ADDENDUM #2

Boys and Girls Club Phase 1
Structural Addendum Number Two
February 28, 2012

BOYS AND GIRLS CLUB
CHEYENNE, WYOMING

FOUNDATION WALL ELEVATIONS

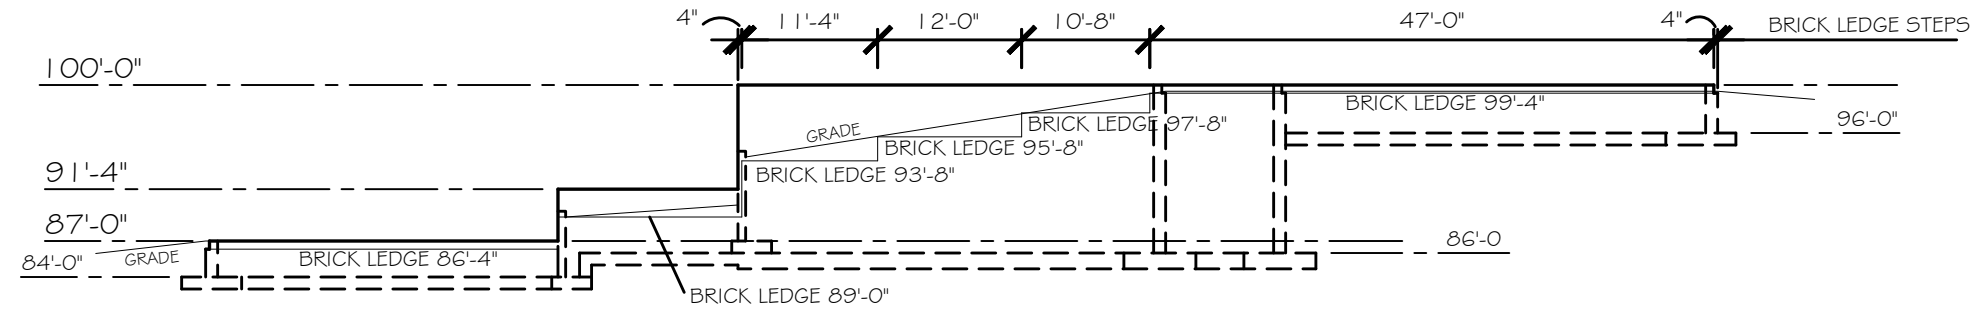
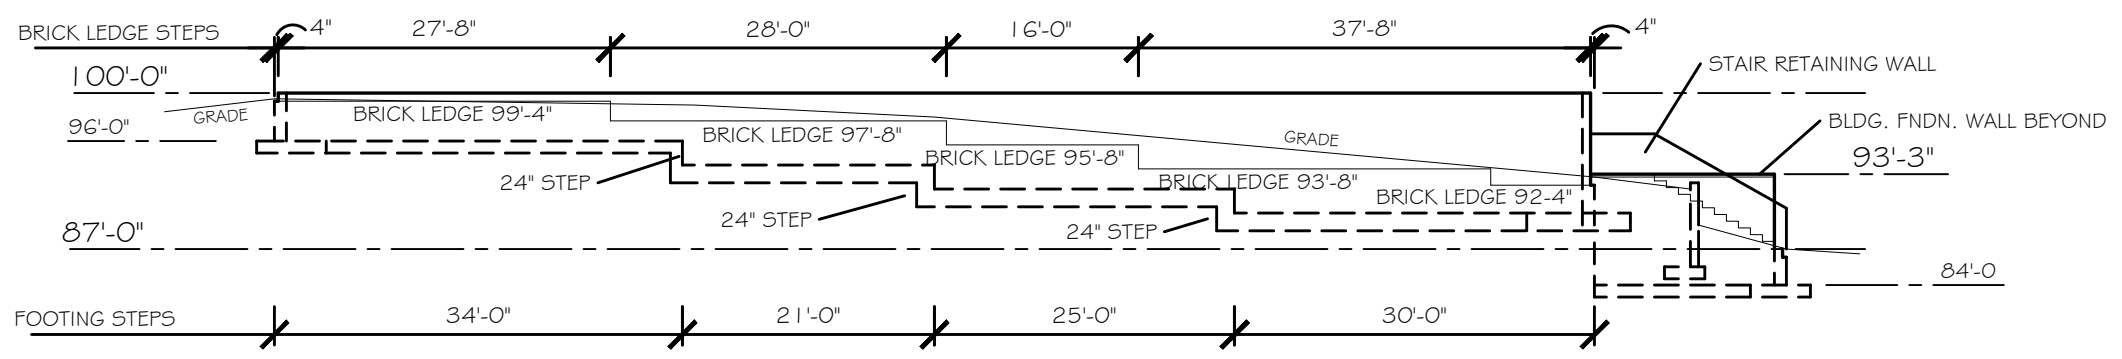
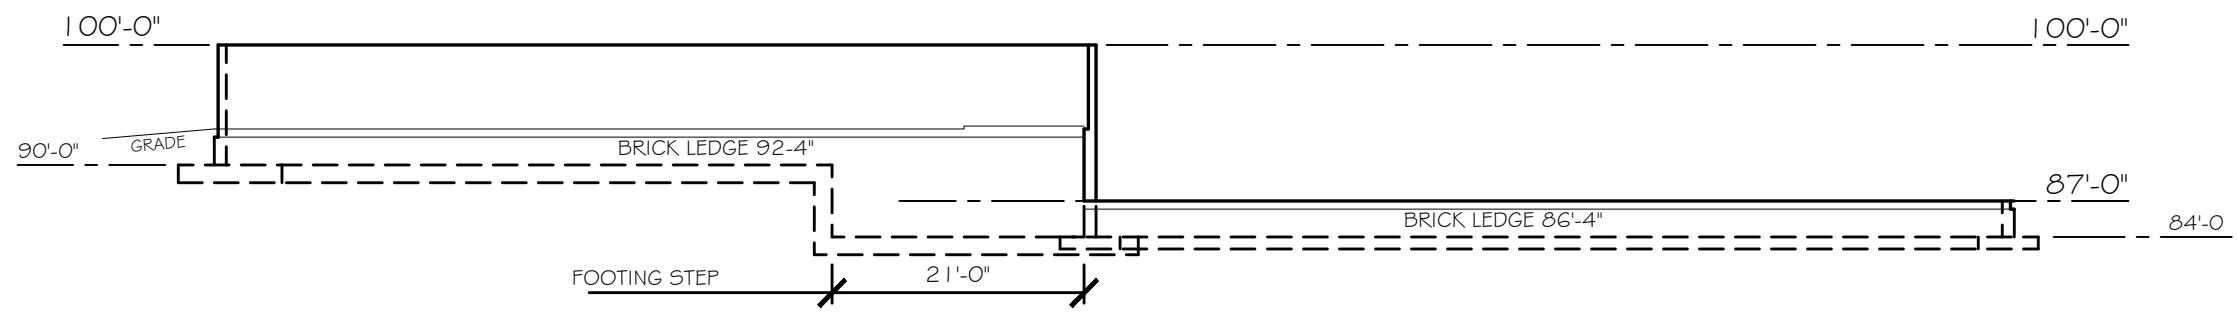
1. Sheet S1: Provide three footing steps on the west wall and one step on the south wall of the gym. Footing sections shall remain as shown – footing K/S6 will continue on the west wall to the same point as originally shown on Sheet S1. See attached Sheet AD2 for locations and elevations of these footing steps as well as elevation views of all foundation walls.
2. Sheet S1: Se Sheet AD2 for locations and elevations of brick ledges and brick ledge steps.
3. Sheets S1 and S2: The exterior stair and landing will not be built as part of Phase 1 work. The retaining wall adjacent to this stair will be built as part of Phase 1 work. See previously issued Sheet AD1 for elevations of this wall.
